RESPONSE TO COMMENTS March 9, 2018

8.0 RESPONSE TO COMMENTS

8.1 SUMMARY OF WRITTEN COMMENTS RECEIVED DURING THE PUBLIC REVIEW PROCESS FOR THE DRAFT EIR

3.1 Aesthetics

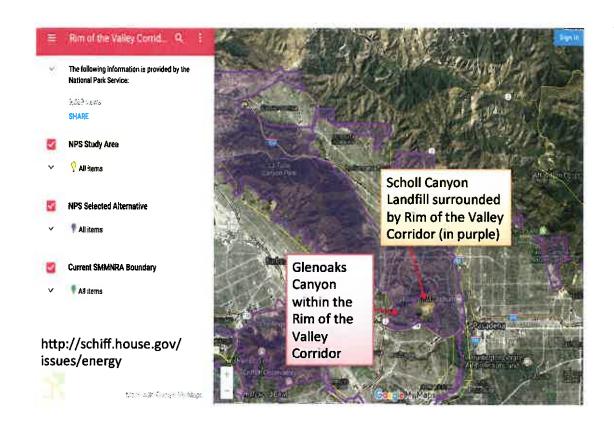
3.1.1 Settings: The discussion on settings in the MND of the Biogas Renewable Generation Project mentions the "natural beauty, such as visual and scenic resources as aesthetic functions that contain natural beauty" and goes on to say "there are no designated scenic vistas near the Proposed Project or within other parts of the existing SCFL, nor are there any designated scenic vistas from which the proposed Project would be visible." Unfortunately, the MND neglected to mention that the beautiful San Rafael Hills surrounding the SCL have been included in the Rim of the Valley Corridor Preservation Act, which would expand the boundaries of the Santa Monica Mountains National Recreation Area. Congressman Adam Schiff is slated to reintroduce this legislation to the House in late October 2017(see following satellite photo).

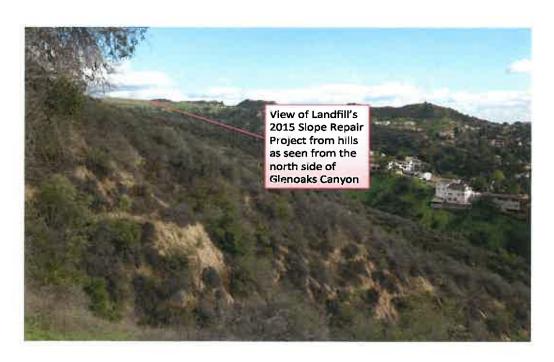
Not including this act in the MND is an oversight, minimizing the importance of the natural beauty surrounding the landfill and which is greatly valued by residents in areas immediately surrounding the landfill. The following photos illustrate the beauty of the area and how the landfill's presence (specifically the 2015 Slope Repair Project" at Scholl Canyon Landfill) has adversely impacted its scenic beauty.

Subsurface Barrier 1 System
Scholl Canyon Landfill Expansion EIR

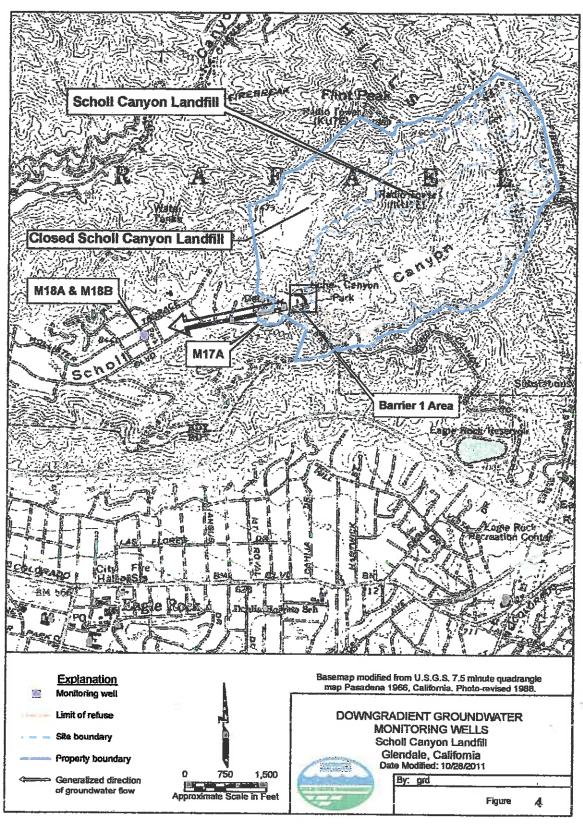
In addition, rainfall (see rainfall averages for Los Angeles below) eventually percolates downward through the landfill and into: (a) the fractured substrate, (b) the aquifer, groundwater, and (c) Glendale's water wells. Increased rainfall exacerbates percolation of chemical constituents into the groundwater.

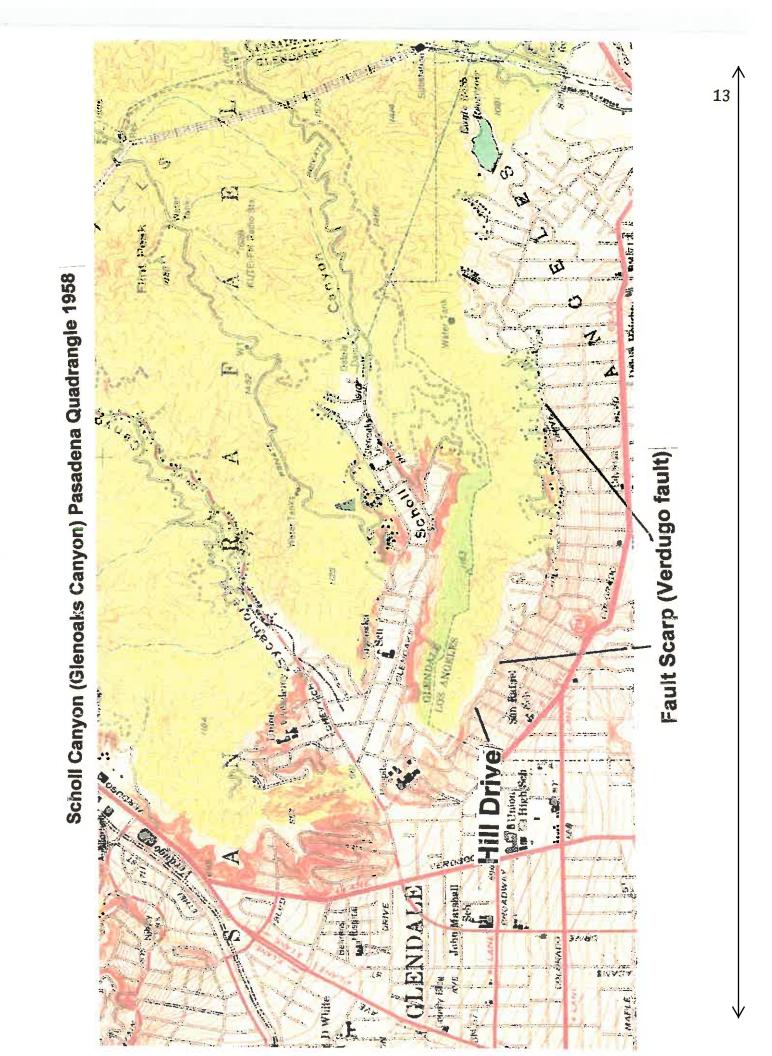
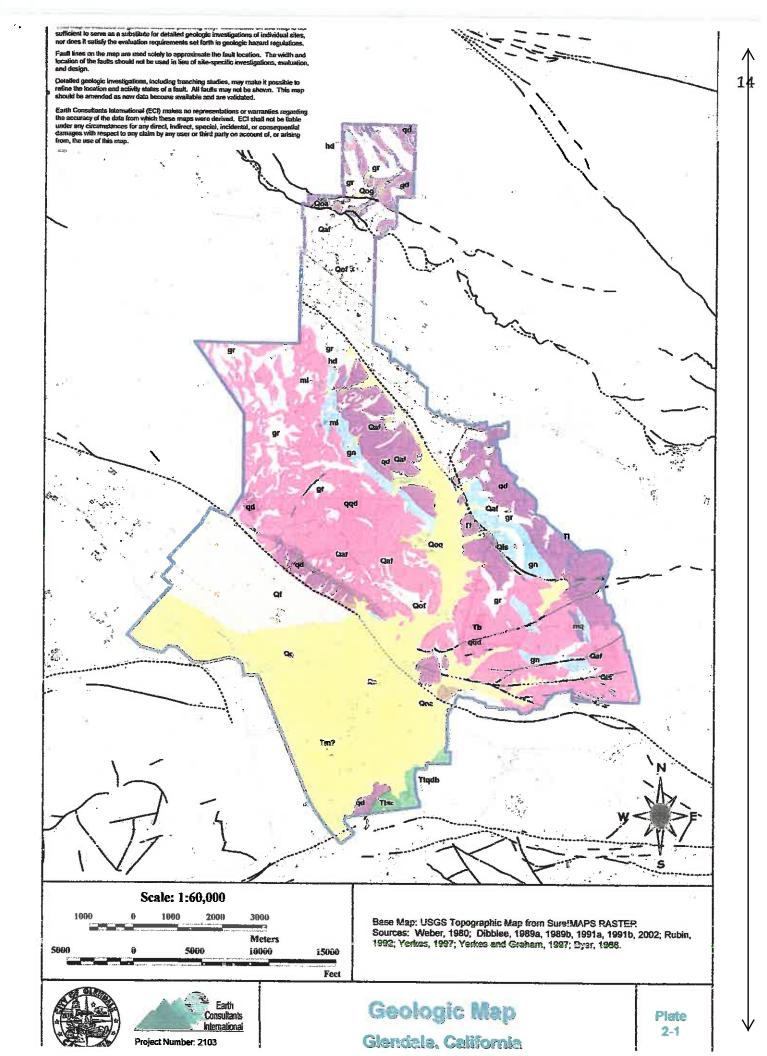
My Comments: Stantec 2017 minimizes the importance of the Verdugo fault. To quote from above: "there is low potential for surface fault rupture from the Verdugo Fault". Because movement within and along the Verdugo fault zone (and along faults mapped within the Scholl Canyon Landfill) could impact any engineered structures at the landfill site, and elsewhere, including the subsurface barrier discussed in my above comments, evidence of the presence of the Verdugo fault, the postulated magnitude of an earthquake near the trace of the Verdugo fault, and the estimated monetary damage that movement along the fault could cause, the Verdugo fault is reviewed below.

Subsurface Barrier 1 System
Scholl Canyon Landfill Expansion EIR

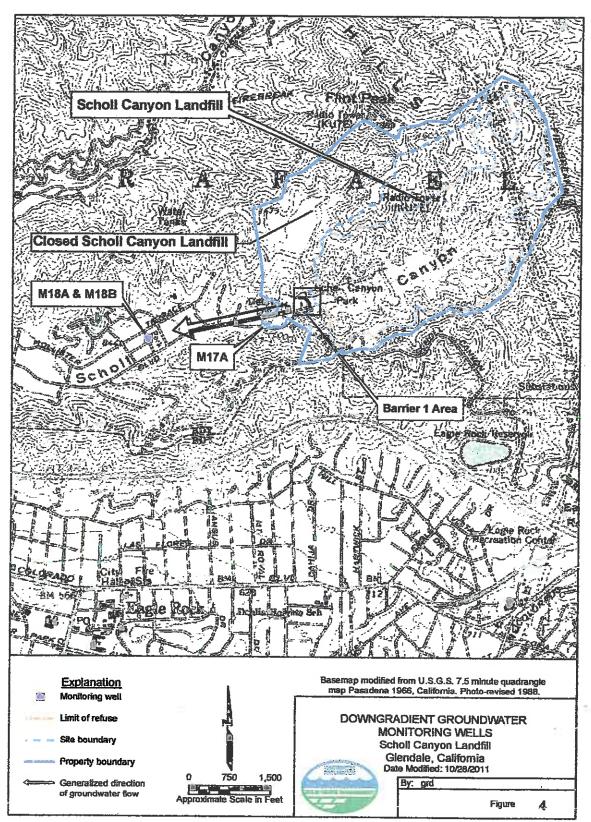
In addition, rainfall (see rainfall averages for Los Angeles below) eventually percolates downward through the landfill and into: (a) the fractured substrate, (b) the aquifer, groundwater, and (c) Glendale's water wells. Increased rainfall exacerbates percolation of chemical constituents into the groundwater.

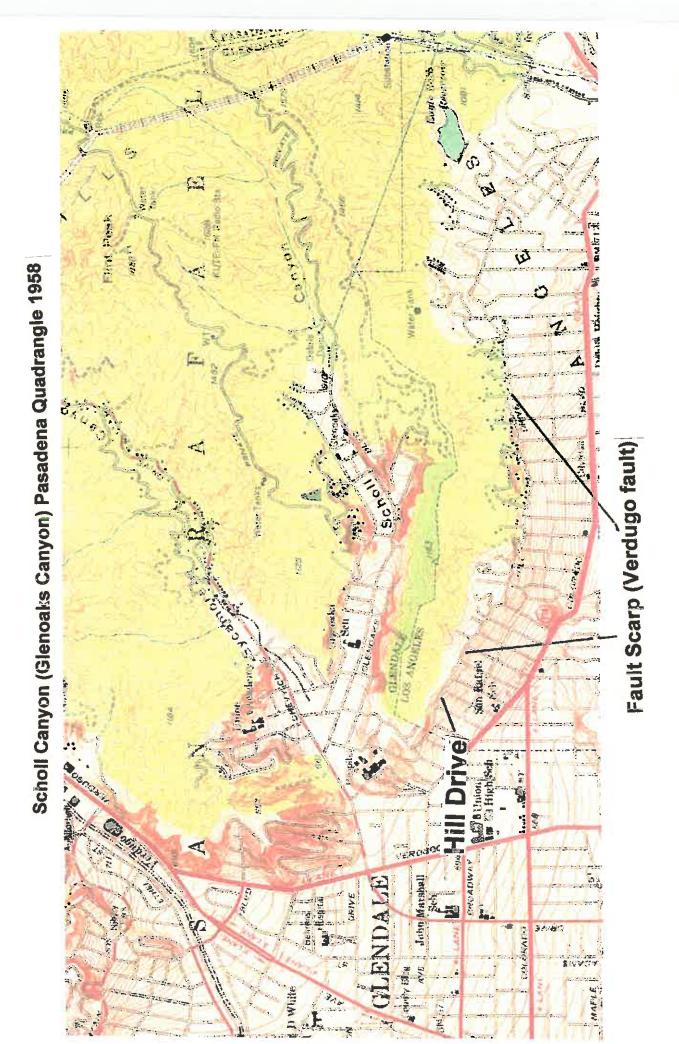
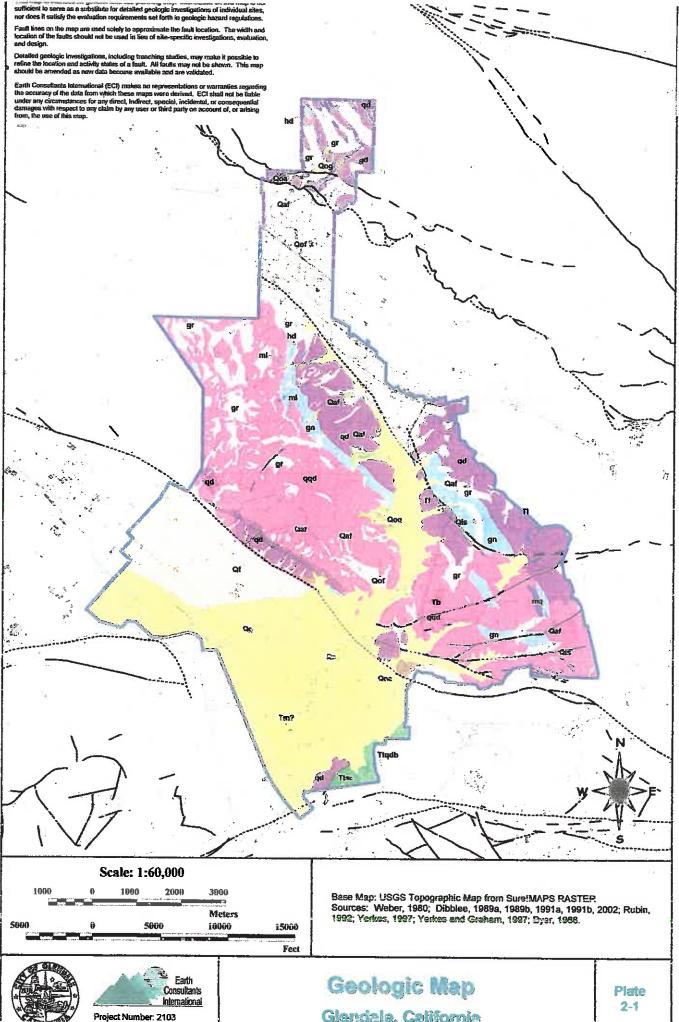
My Comments: Stantec 2017 minimizes the importance of the Verdugo fault. To quote from above: "there is low potential for surface fault rupture from the Verdugo Fault". Because movement within and along the Verdugo fault zone (and along faults mapped within the Scholl Canyon Landfill) could impact any engineered structures at the landfill site, and elsewhere, including the subsurface barrier discussed in my above comments, evidence of the presence of the Verdugo fault, the postulated magnitude of an earthquake near the trace of the Verdugo fault, and the estimated monetary damage that movement along the fault could cause, the Verdugo fault is reviewed below.

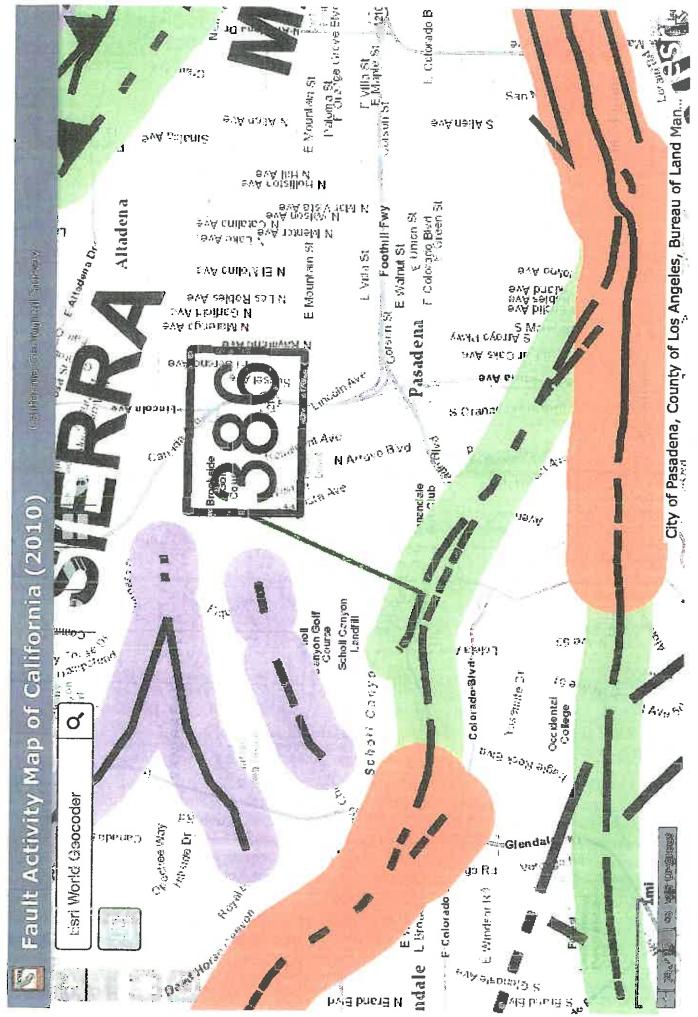
A strand of the Verdugo fault (green), depicted on the fault activity map, < 0.5 mi. south of the landfill, is estimated to have been active between 700,000 years (Pleistocene Epoch) and the Holocene Epoch (i.e., between 11,700 and 200 years).
